# 6-30 Artarmon Rd Willoughby Review

## Concept Plan Review

Prepared for Willoughby Council  
September 2016

Willoughby City Council  
**6-30 Artarmon Road, Willoughby**  
Traffic Impact Assessment Review

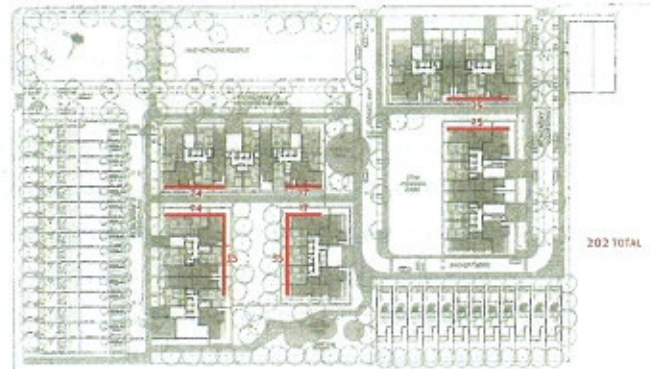
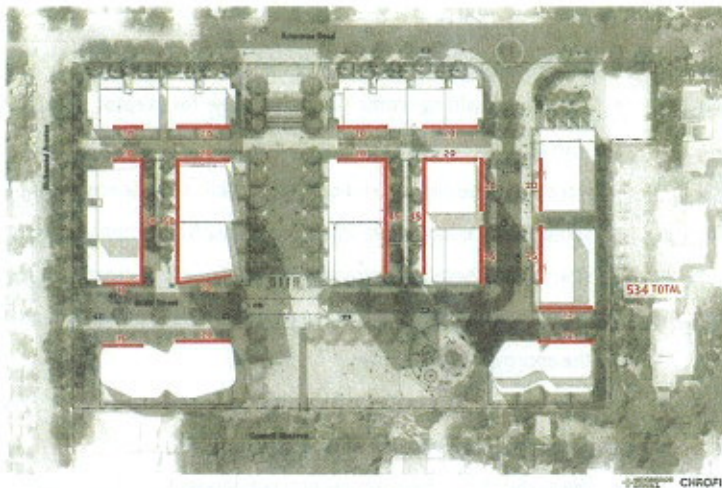
- Building separation requirements more specifically, have also been adhered to. However the diagrams above illustrate the general impact that the overall change in density has on the collection of built forms, in a way that goes beyond the minimum requirements of the Apartment Design Guide. The building frontages highlighted in red denote where a building facade is facing another building less than 25m away, in the proposed concept plan on the left and the approved plan on the right.

- Although many of the proposed units face onto the new public spaces and Scott Street, and not into the narrower communal spaces, there is a marked increase from the approved scheme in the length of building forms that face other building forms.

- Whilst the minimum separations have been achieved, we believe the resulting outlook from many units will be of lesser quality. And that more broadly, the collection of built forms in the proposed concept plan will appear too closely spaced when viewed from the new public domain on the site.

5. Modification of the proposed forms (Buildings E and F) around Tree #32 and potential site linkages should also be undertaken to reduce the overall length of building frontage provided on the site with minimal separation to other buildings. We believe the length of building facades facing other buildings less than 25m away could be reduced by some 200m.

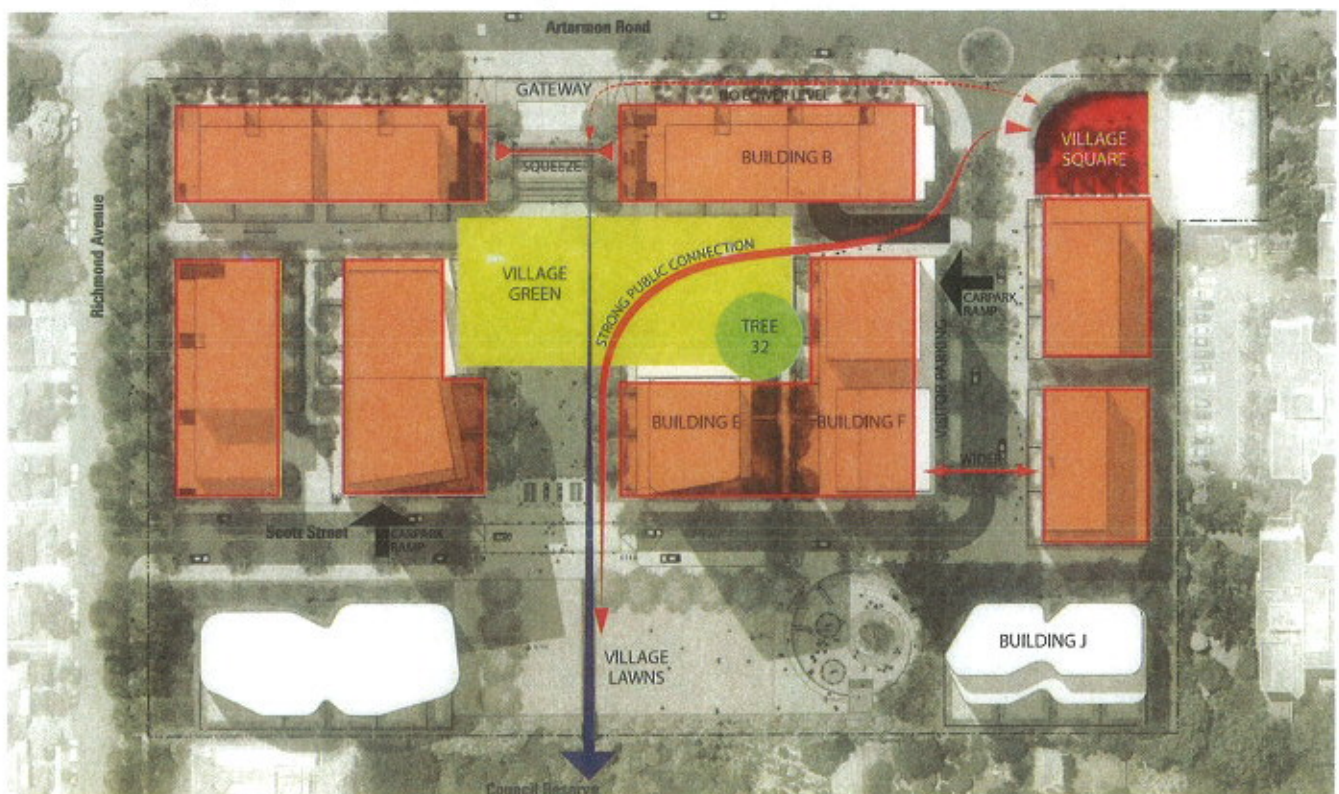
In light of the concept plan review provided above, ten conclusions are provided here and illustrated generally in the diagram below. We believe that incorporation of these matters into an amended version of the proposed concept plan may require a reduction in the vicinity of 30 apartments to the total number of dwellings in the proposed concept plan.

1. Allen Jack + Cottier believe that additional public open space, more commensurate with the proposed increase in dwelling numbers, should be provided in the proposed concept plan.

2. More careful consideration for the programme/uses of Village Green is required to better inform the design of this public open space so that it creates a more diverse contribution to the public open space and maintains the view corridor identified in the overall site planning strategy.

3. Further assessment of anticipated pedestrian traffic should be used to inform the design strategies of Village Square and the Gateway as the two major pedestrian access points to the site. And by virtue of this, site linkages that improve pedestrian access the rest of the site should be incorporated into the public open space design.

4. Retention of Tree #32 should be considered for its own merits and as an opportunity for it to contribute to improved site linkages and additional public open space.

6. The applicant should be required to demonstrate the relative impacts of Building J on the outlook from units in the adjacent Castle Vale Development and the solar access to the properties along Walter Street.

7. The units facing Artarmon Road on the lowest level of Building B should be removed to improve this building's relationship with the low scale residential context of Artarmon Road.

8. The proposed vehicular entry near Village Square should be moved to conceal it in/under a built form and minimise encroachment on open spaces/site linkages.

9. A second vehicle access point to the subterranean parking that improves the sense of address and traffic impacts in peak times should be provided.
10. The building separation along Scott Street should be widened to allow for a larger provision of kerbside visitor parking.

Figure 2 Site access points

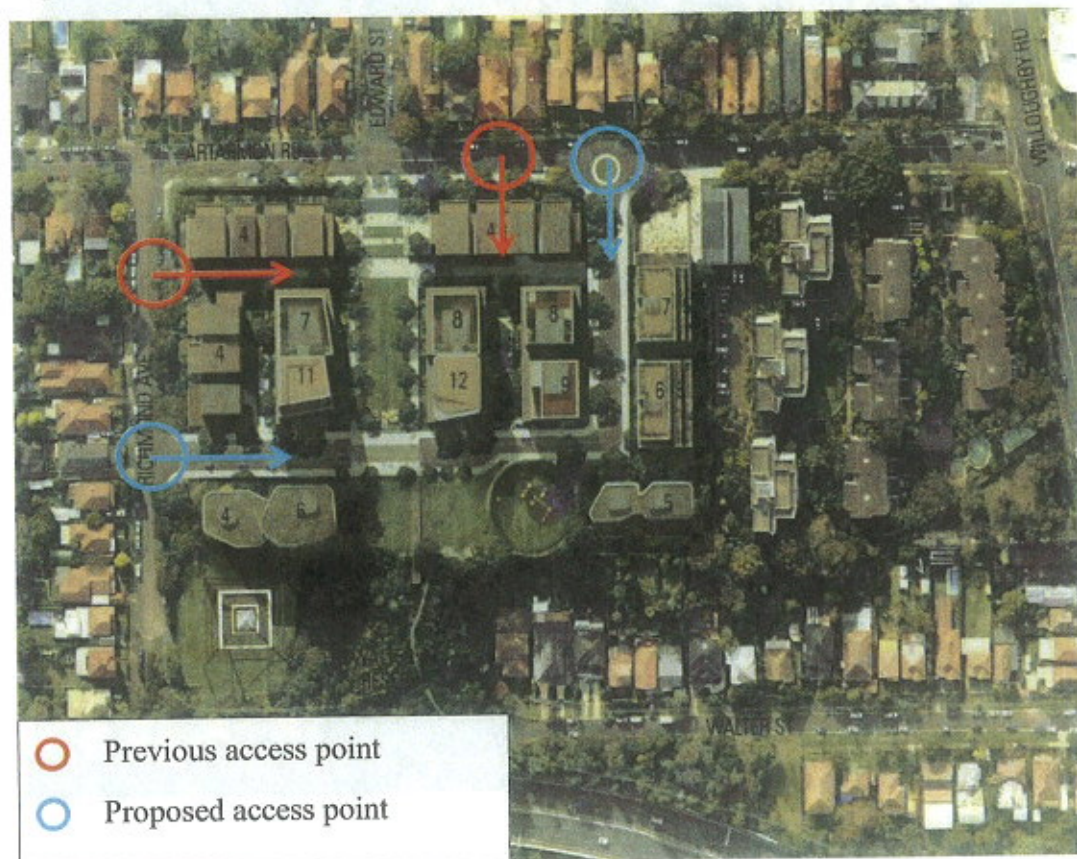
The revised master plan proposes similar access arrangements to that in the approved concept plan – that being a two-way internal road that links the two access points on Artarmon Road and Richmond Avenue. While the location of the entry points have shifted slightly from those in the approved concept plan (see Figure 2), this is not expected to have a significant impact on the operation of the road network. The relocation of the Artarmon Road access point further east improves the site distance for vehicles departing the site and turning right towards Willoughby Road. As previously noted in Arup's 2013 study, based on the requirements outlined in Austroads Guide to Road Design, with a road design speed of 50km/h, a safe intersection sight distance (SISD) upwards of 100m is required. The relocation of the site access point achieves this distance.

Figure 3 Vehicle swept path analysis

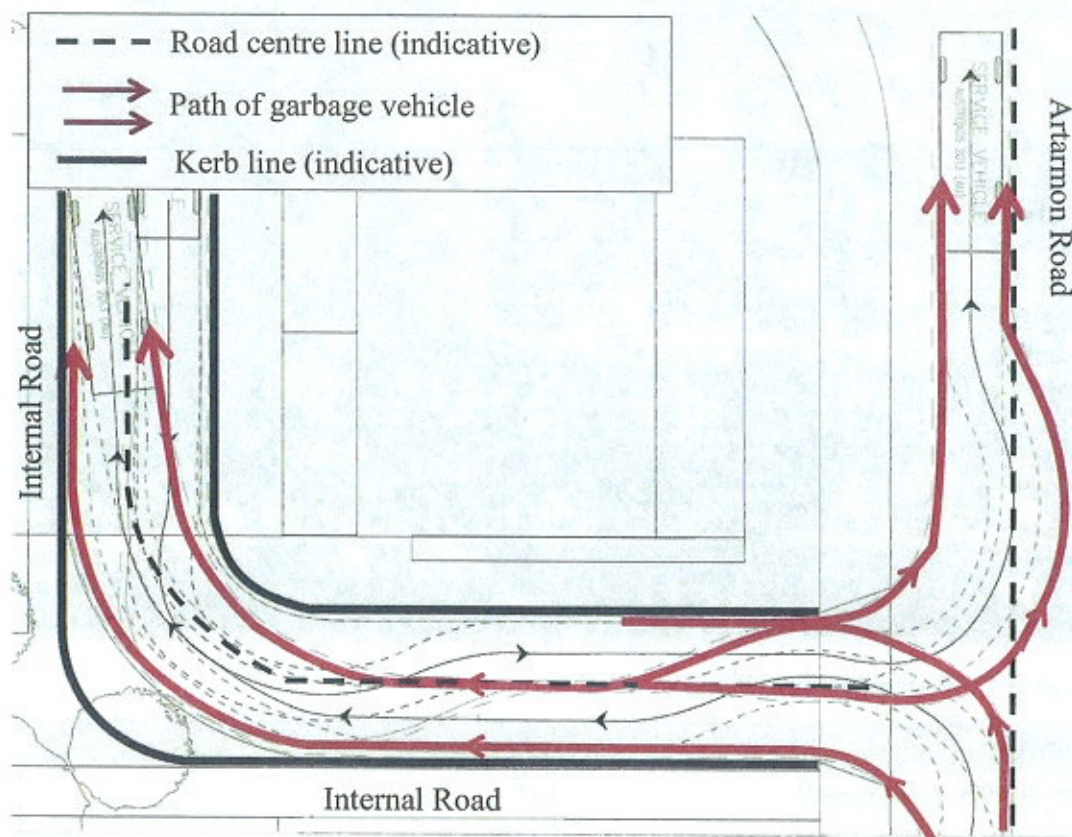
The design of the internal road system has been reviewed against relevant standards and guidelines. While the internal road allows for two standard cars to pass one another at any one time, vehicle swept path analysis indicates a 9.8m long garbage vehicle crosses the road centre line when manoeuvring within the site. This is illustrated in Figure 3, and would mean that a standard car could not pass this vehicle type when driving within the site – creating safety issues. The vehicle swept path diagram provided by the applicant does not indicate any on-street parking bays on the internal road within the site.

A further issue with the internal road design noted in this review included that a medium rigid vehicle (8.8m long garbage truck) was adopted as the largest design vehicle. Given some furniture removalist trucks may be larger/longer than this, a 12.5m heavy rigid vehicle is typically adopted as the design vehicle.

An amended design should be prepared which demonstrates a service vehicle can safely pass an oncoming car, including the presence of vehicles parked on the internal street.
